AMENDMENTS TO G06 + G47
 FIRE EXIT / ESCAPE
 28731-SOAS-A-SKE-XXX-XX-0158

TEMPORARY FIRE STRATEGY

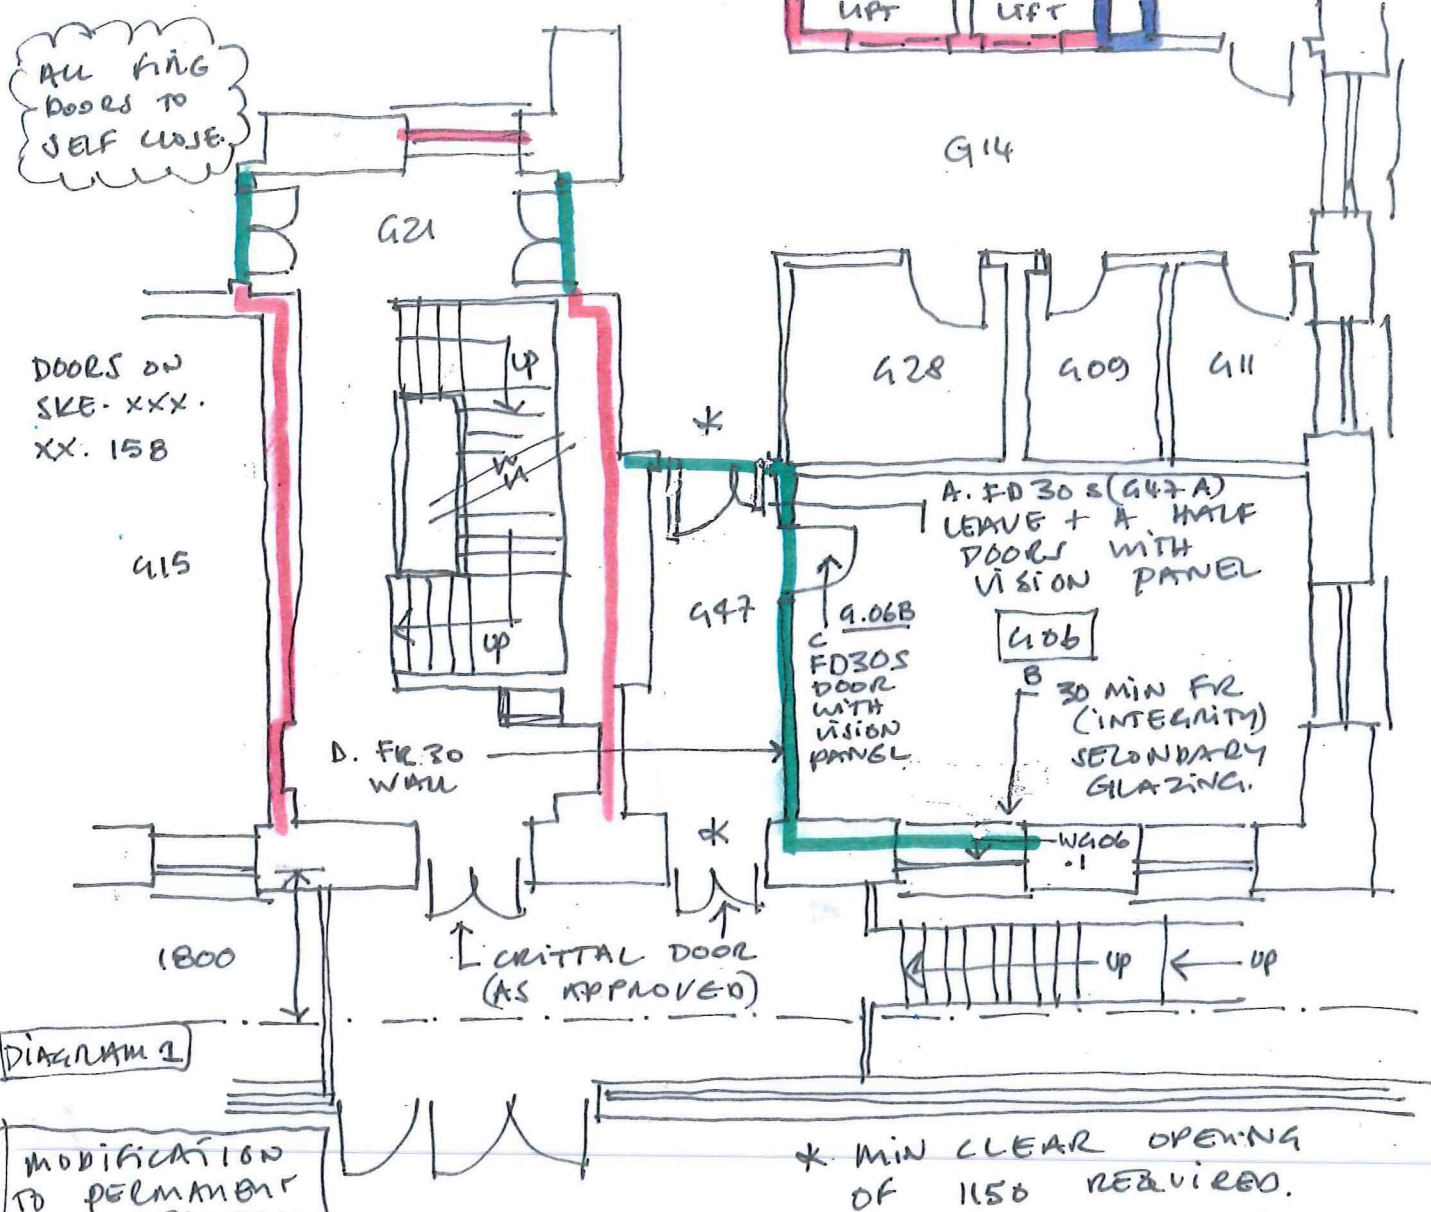
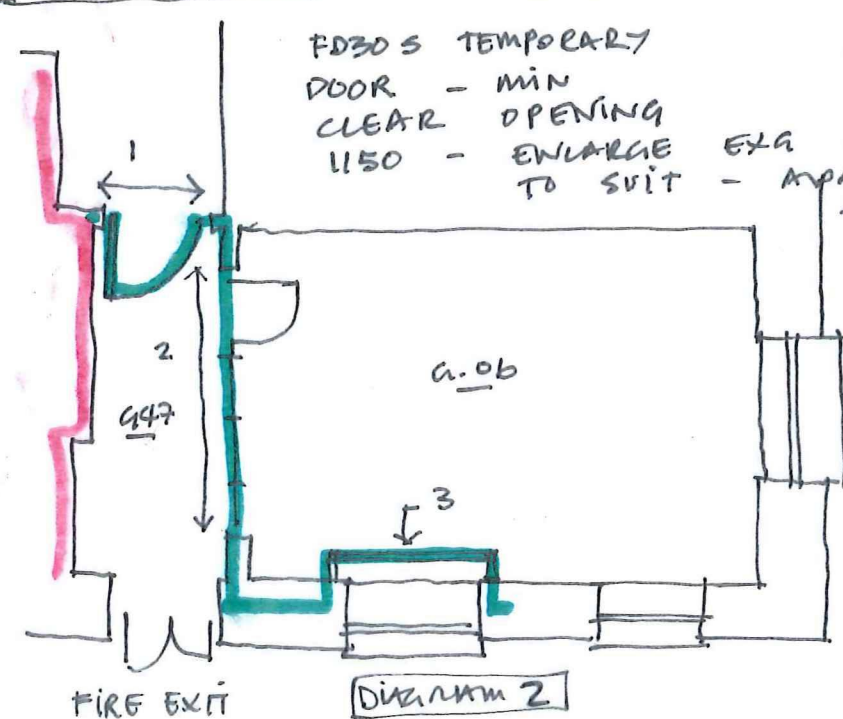
1. EXA STRUCTURAL OPENING
 APART EXA / NEW SKIRTING
 + LININGS TO ACCEPT
 TEMP (+ THEN FINAL DOOR)
2. ISOLATE ROOM G.06
 FROM USE (MANAGEMENT)
 SOLUTION
 OR
 REMOVE WALL / OVER
 CLAD TO GET 30 MINUTE
 PROTECTION TO G47.
3. 30 MINS (MIN) PROTECTION
 TO STAIR OVERS,
 SHAFTWALL / IWL
 ↓
 TYPE 19
 ↓
 TYPE 9 or
 10
